## TSB - JD04

Models applicable > John Deere 5200 to 5700 series

Ag Clutch Part numbers > 228 2801 JD and 628 2801 JD

### CLUTCH KIT REPLACEMENT

228 2801 JD (Omg)

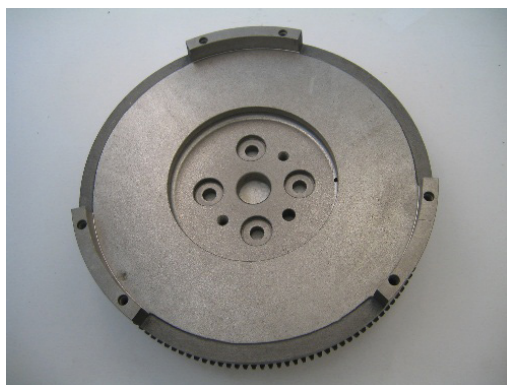
The original assembly has both main and PTO discs integrally fitted

The LuK aftermarket assembly has integral main and loose PTO discs

When replacing the original Omg clutch assembly with the aftermarket LuK clutch kit, the flywheel must have the lower mounting face machined out until the total depth of the flywheel = 24.6mm if the clutch disc is 12.0mm overall thickness.

If the clutch disc is 7.6mm thick then the flywheel recess needs to be modified to 20.0mm. This lower face is then utilized as a conventional style flywheel allowing the operation of the modified PTO disc, whilst incorporating the same Safety PTO style release mechanism. The LuK kit contains the modified PTO disc, a new bolt set and replacement PTO bearing with housing.

Note > This must be installed as matched set only, and must not be interchanged with the original Omg individual components.
